Flight Procedures Cover Page	Task Action: ABBREVIATED AMEND	Task Type: IAP	Estimated Chart Date: 05/14/2026	APWS Task ID: 14239643A347480383A0EC641EC1A9EC	APWS Project ID: 0BAE08E4B5CC4AA48E30864122C5ABE1
Procedure: ILS OR LOC RWY 17 AMDT 15A		Enroute: NO	Specialist: Young, Silvia		Agreement Number:
Airport ID: KSLC			Airport City: SALT LAKE CITY		State: UT
Facility ID: BNT	Facility Type: ILS	Flight Inspection Remark Type: New FC Slot			
<p>Procedure Comments: ACTIVE DATA USED FOR SLC AIRPORT AND RWY.</p> <p>ACTIVE DATA USED FOR I-BNT, FFU VORTAC, OGD VORTAC, PVU VORTAC AND TCH VORTAC.</p> <p>MEMO: AFS BLANKET WAIVER TO OMIT CAPTURE FIX REQUIRED ON PBN TO ILS APPROACHES.</p> <p>WAIVERS (4):</p> <ol style="list-style-type: none"> 1. UTILIZE THE LOCALIZER TRAPEZOID EXTENDED FOR OBSTACLE EVALUATION VICE THE STANDARD CONVENTIONAL TRAP FOR THE INITIAL AND INTERMEDIATE SEGMENTS. 2. FOR SPEED RESTRICTIONS OF "AT OR BELOW 250 KIAS" AT THE EKKHO. 3. FOR LEG LENGTH WAIVER FOR INITIAL LEG SEGMENT (2). 4. WAIVER FOR PAT 3 AND 5 NOT TO PLANT AAO WITHIN 1000FT OF FFU VORTAC TO MAINTAIN 9000 AS MINIMUM HOLDING ALTITUDE. <p>ALTERNATE MISSED APPROACH NEEDS TO GO THROUGH FC DUE TO TCH VORTAC PREVIOU

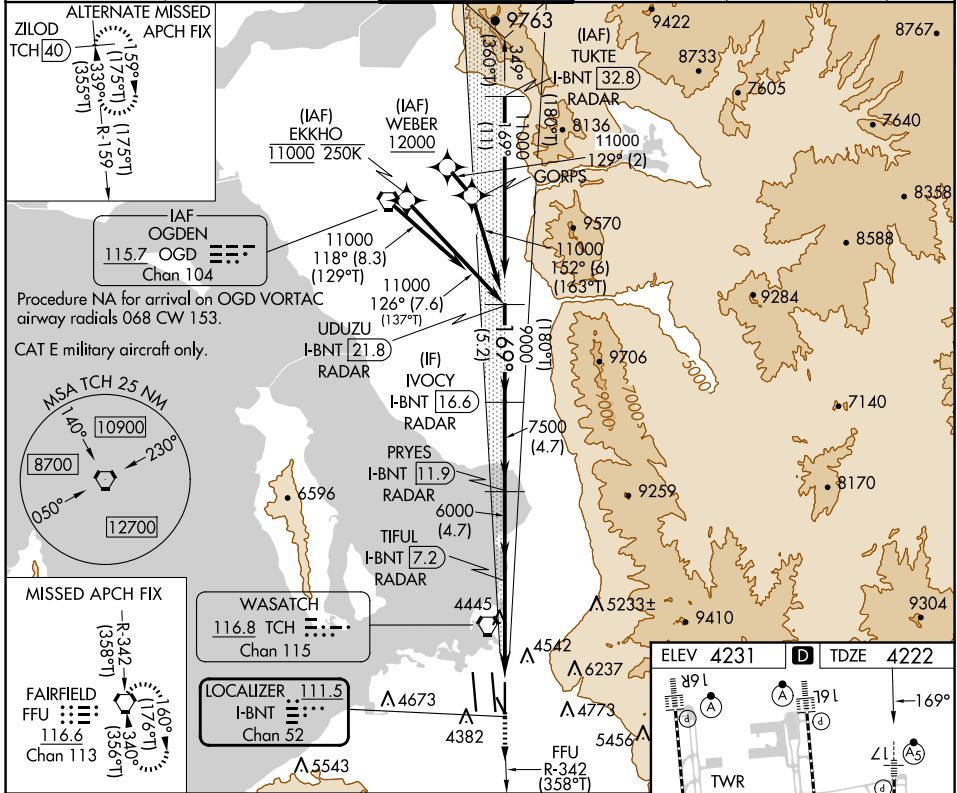
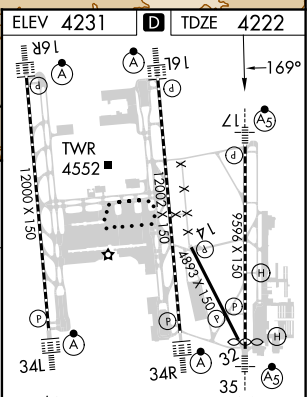
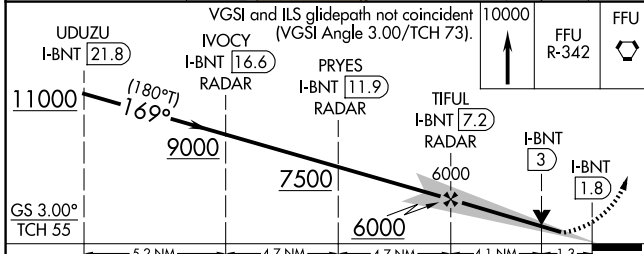
Simultaneous approach authorized. For inop ALS, increase S-ILS 17 Cat E visibility to RVR 4000, increase S-LOC 17 Cat C/D/E visibility to 1 3/8 SM.
